DATE: November 9, 1983

SUBJECT: Site Visit to Reid Supply, Wichita, Ks.

FROM: Karen Flurnoy

a rough sketch of the driveway areas:

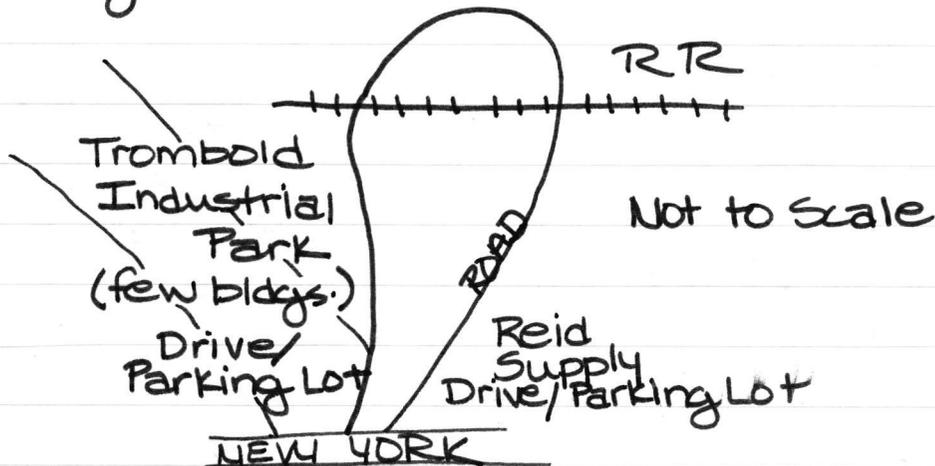
1. Contiguous - we requested that they provide a more detailed map of the properties & access. Contiguous means that there must be direct ~~across~~ access across a public r-o-w without traveling along a public r-ow/road.
